**MONTGOMERY COUNTY HISTORIC PRESERVATION COMMISSION**  
**STAFF REPORT**

<b>Address:</b>	7209 MacArthur Blvd., Bethesda	<b>Meeting Date:</b>	12/7/2022
<b>Resource:</b>	Contributing Resource <b>Potomac Overlook Historic District</b>	<b>Report Date:</b>	11/30/2022
<b>Applicant:</b>	Kim & Arthur Newmyer (Robert Black, Architect)	<b>Public Notice:</b>	11/23/2022
<b>Review:</b>	HAWP	<b>Staff:</b>	Dan Bruechert
<b>Permit No.:</b>	1008960	<b>Tax Credit:</b>	Partial
<b>Proposal:</b>	Partial demolition and construction of a new rear addition, hardscape alteration, and fenestration alterations.

## Response to Historic Preservation Commission Preliminary Consultation Report

Re: 7209 MacArthur Blvd, Bethesda, MD

LOWER LEVEL DEMO PLAN

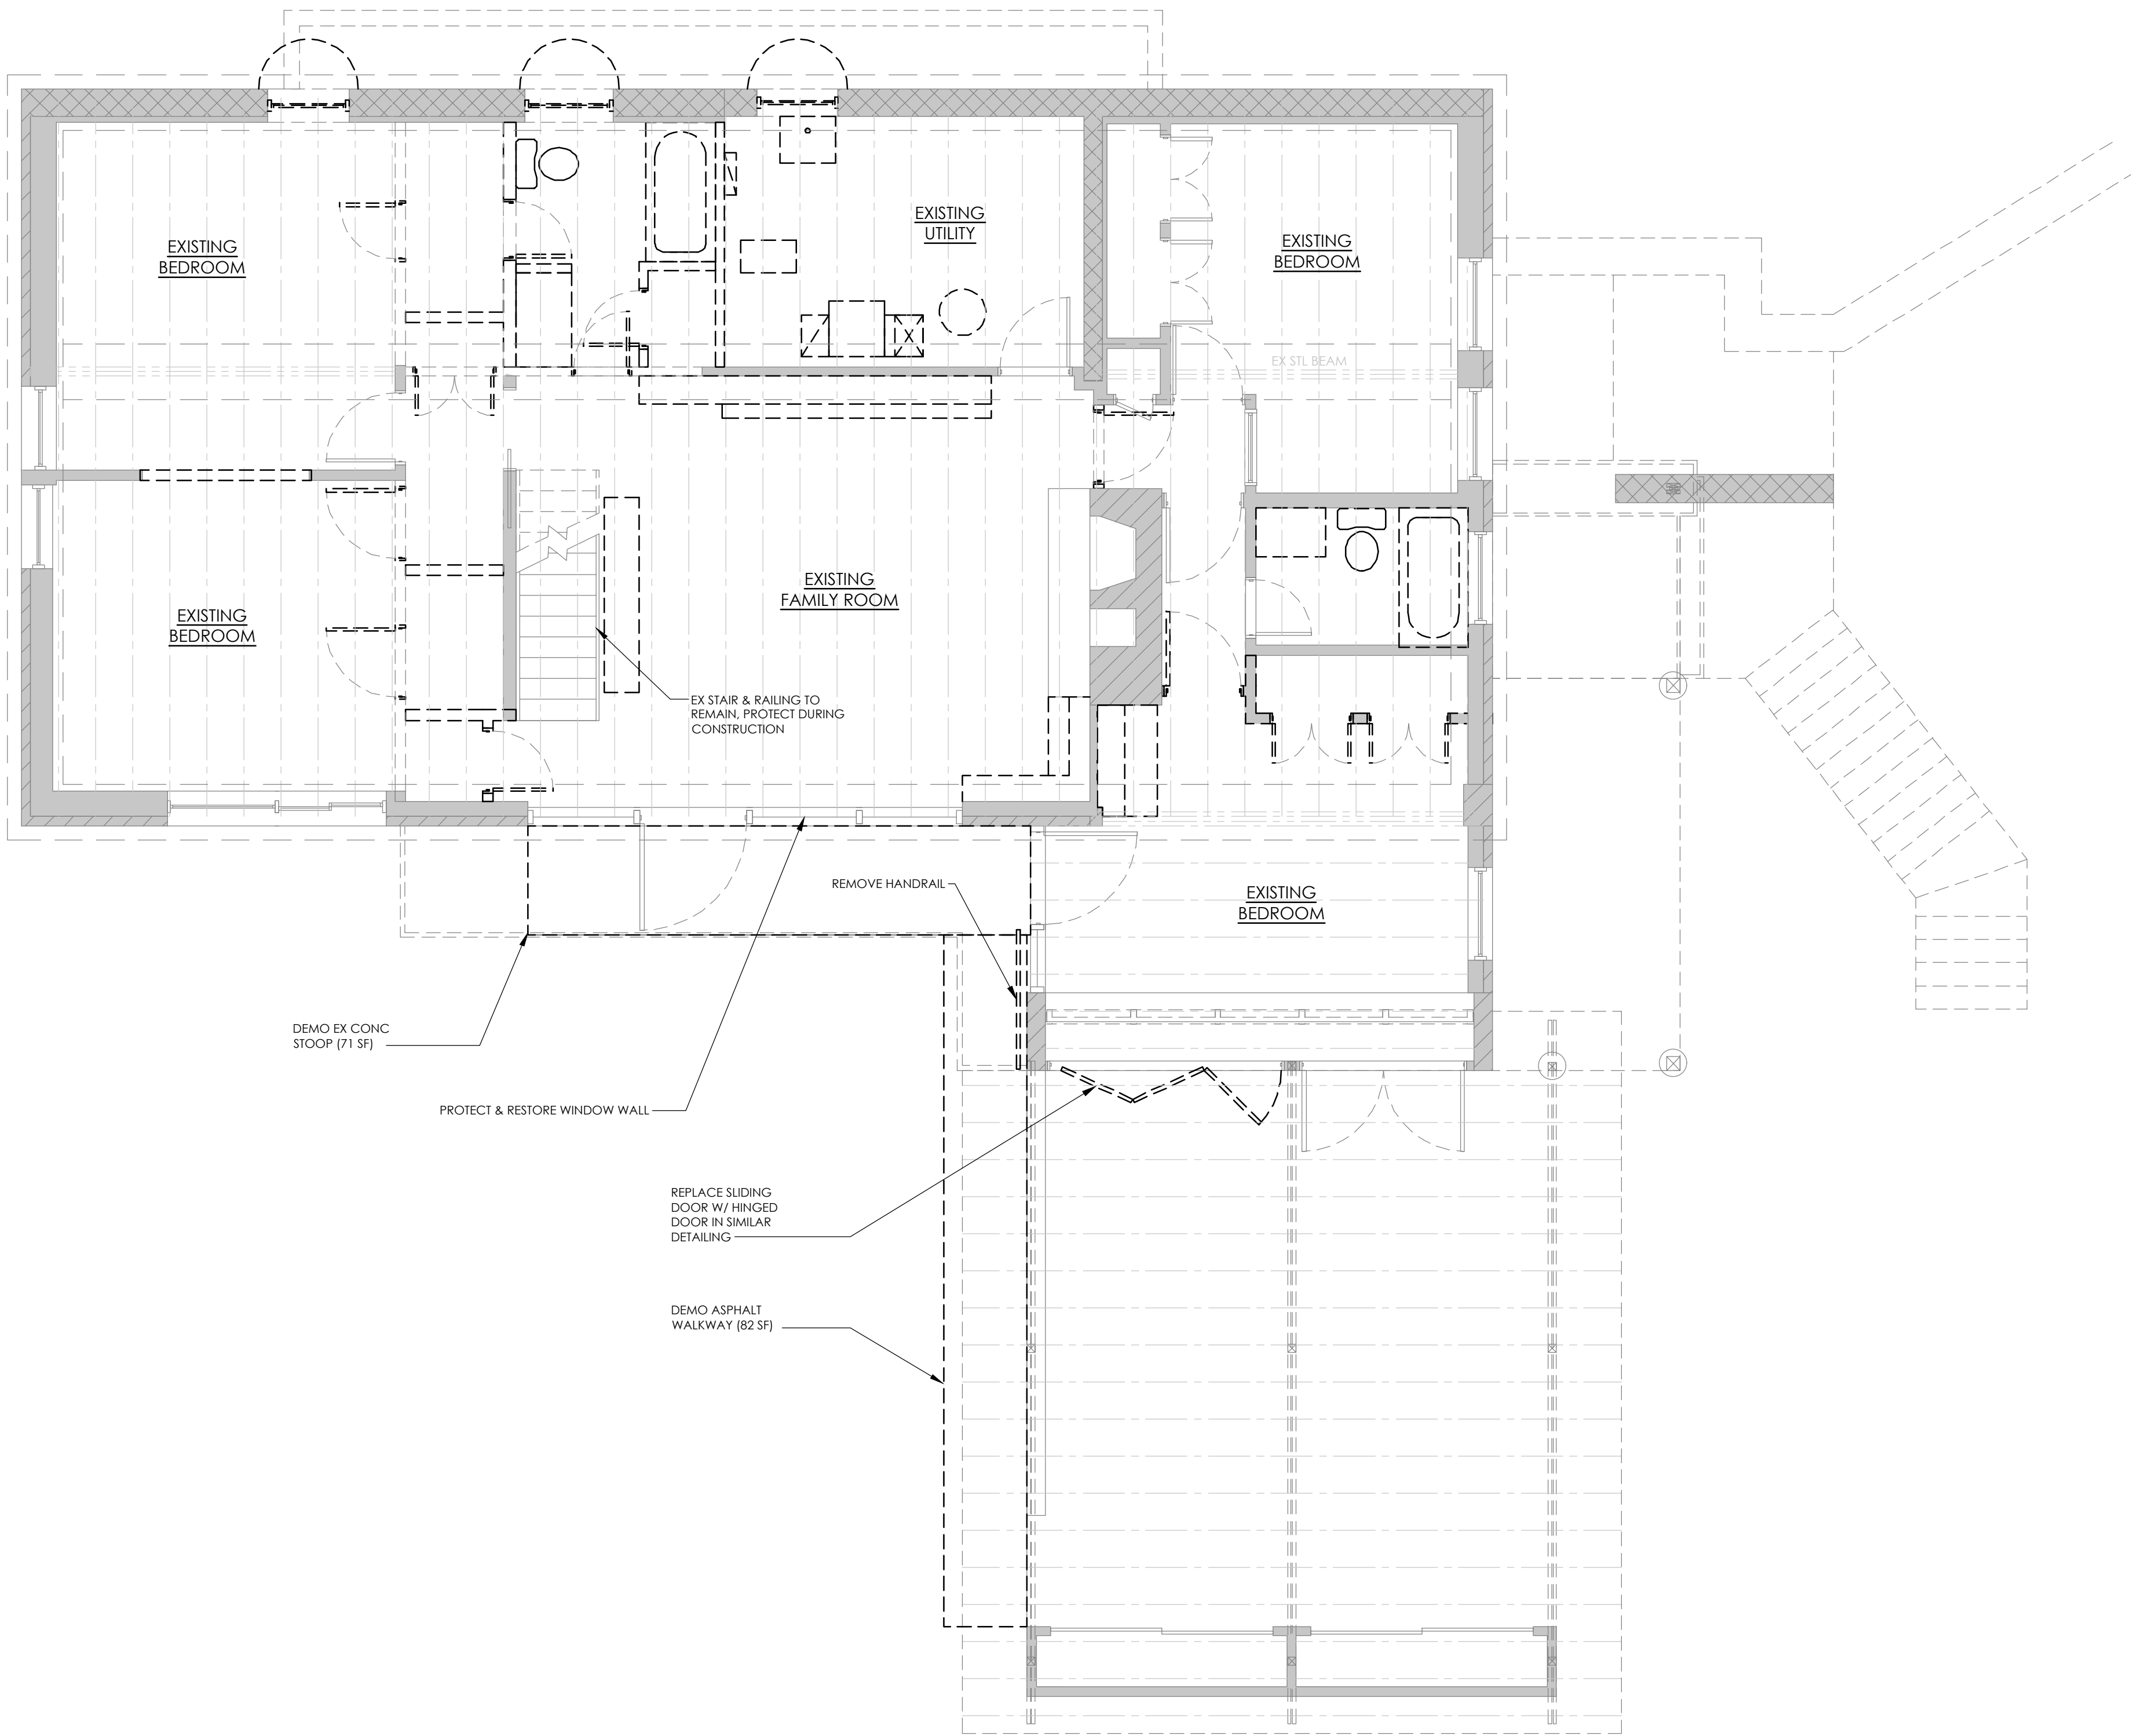
- **Comment:** *Staff noted that if the proposed hardscaping adds less than 100 sf of paving, that proposal can be approved at the Staff-level.*

**Response:** The rear hardscaping has been deleted from the scope due to costs. The Lower-Level stoop and walkway will be mortar set stone over reinforced concrete. The proposed renovation of stoop and walks adds 77 sf to the existing area. See drawings, A100 & A102.

2 NORTH EAST ELEVATION - PROPOSED

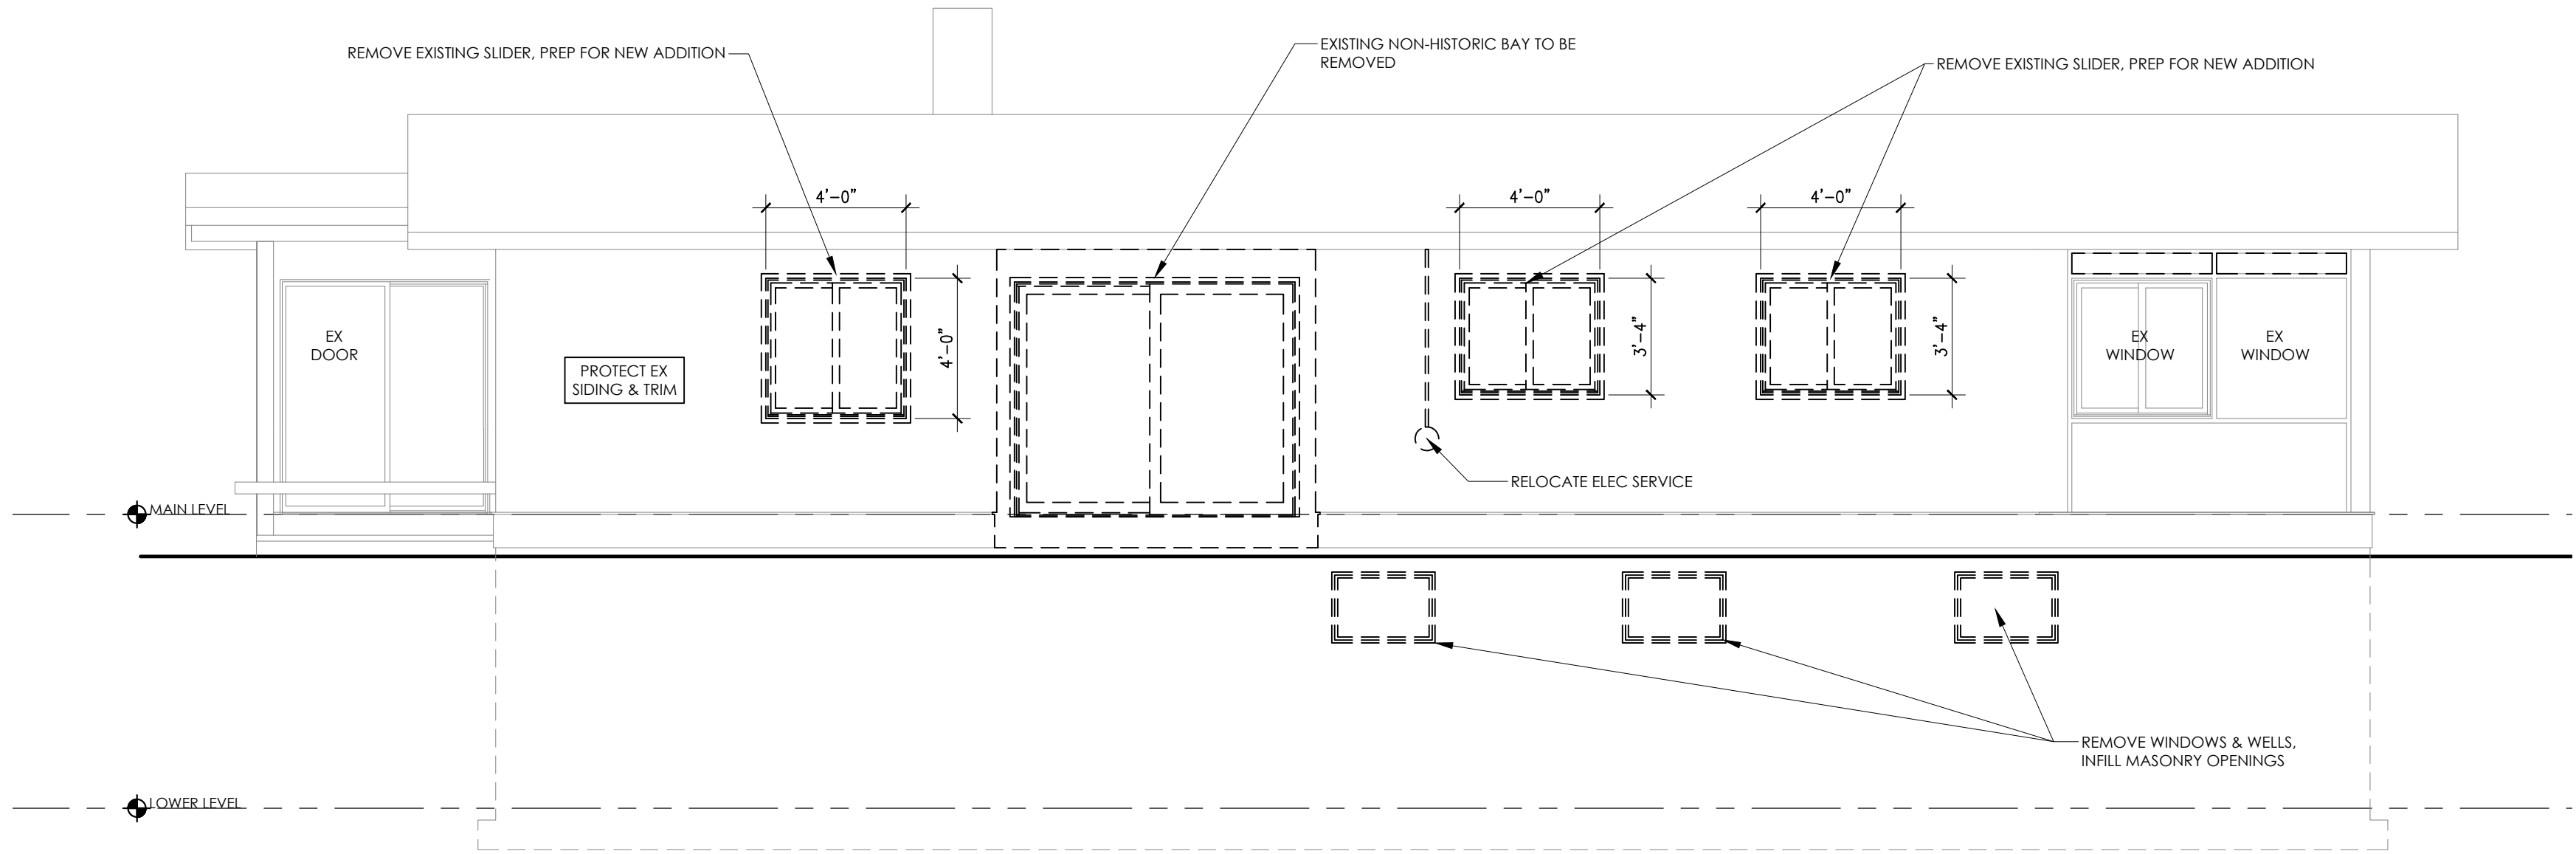
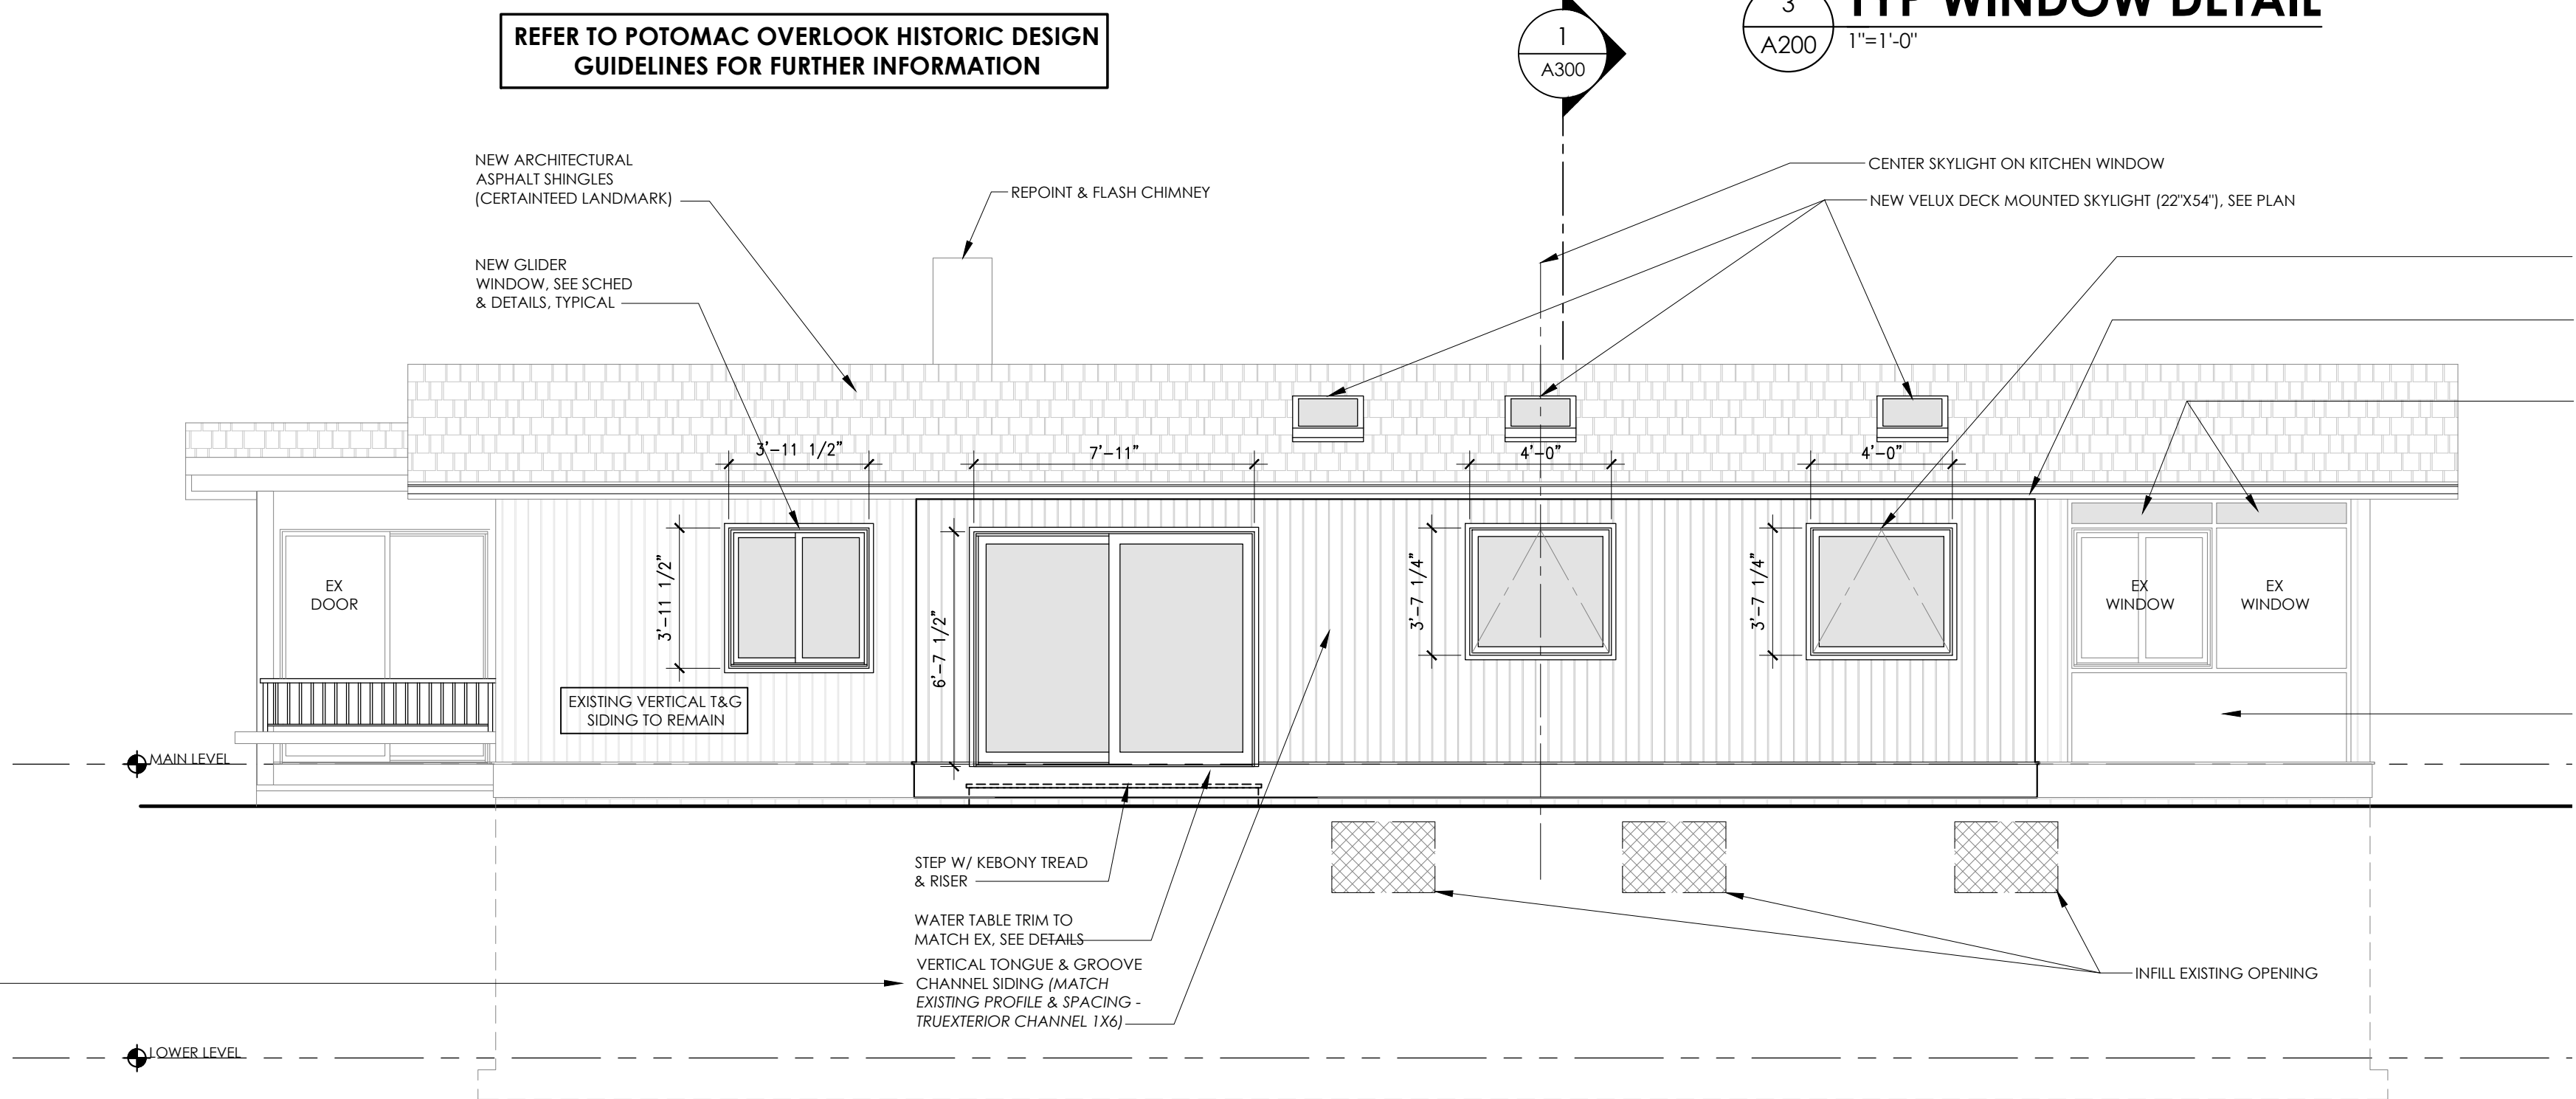
- **Comment:** *There was discussion between the Commissioners where several found that the rear fenestration was acceptable, and others supported replicating the existing fenestration on the rear addition. Staff recommends replicating the existing fenestration pattern.*

- On the North East Elevation (A200) we are proposing to replace two existing broken transom panels in kind.
- Drawing A200 includes a specification for the proposed siding. Spec: TruExterior Channel Siding.

**Response:** The proposed rear fenestration pattern has been revised to replicate the existing pattern (See drawings A200, A201, A203, A300). The proposed windows are Marvin Ultimate aluminum clad wood framed awning windows (A800 shows section details of units proposed). The unit size is similar in width, height and the sills align. Placement is approximate to the existing. The vinyl window to the left of the proposed sliding glass door is being replaced with a Marvin Ultimate aluminum clad glider type unit. The size matches the original historical units.
